MILITARY SPECIFICATION

TRIPOD, SURVEYING: EXTENSION-LEG-TYPE

This amendment forms a part of Military Specification MIL-T-14091D(ME) dated 23 November 1981 and is approved for use by the US Army Mobility Equipment Research and Development Command, Department of the Army and is available for use by all Departments and Agencies of the Department of Defense.

FIGURE 1. Instrument fasteners tripod head, with plumbline holders. X-3219B

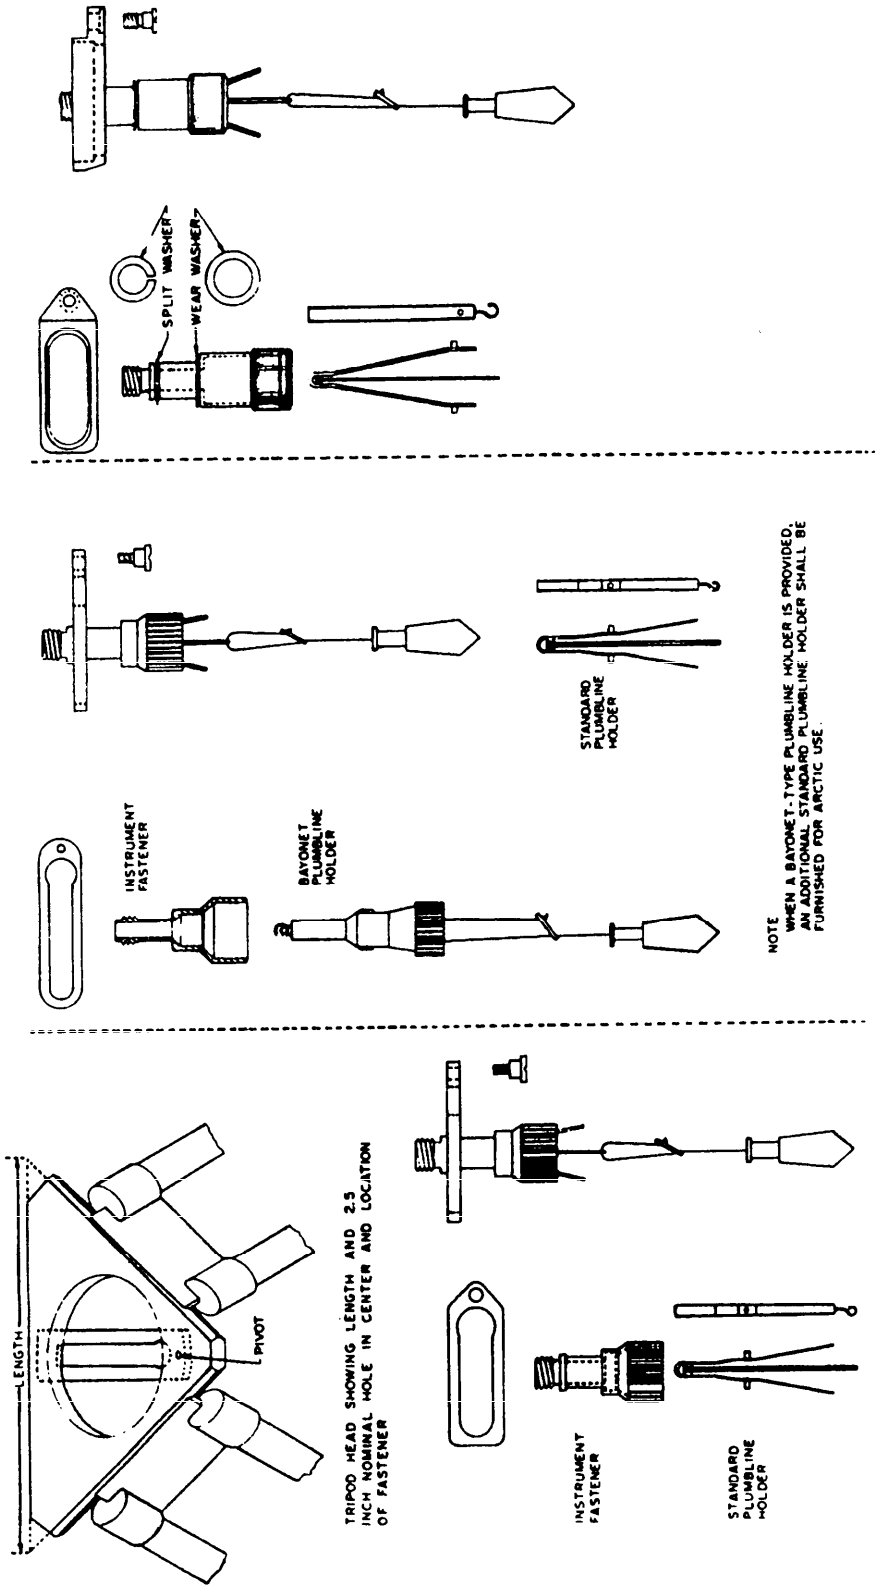
3.1, line 4, delete "instrument fastener fixture" and substitute "plumbline holding device. When a bayonet-type plumbline holder is provided, an additional standard plumbline holder shall be furnished for arctic use (see figure 1)."

"6.5 Information figure. Figure 1 shows types of fasteners which have been found acceptable; however, the figure is included for illustration only and is not intended to preclude the furnishing of another fastener which conforms to this specification."

Figure 1, delete and substitute new figure 1.
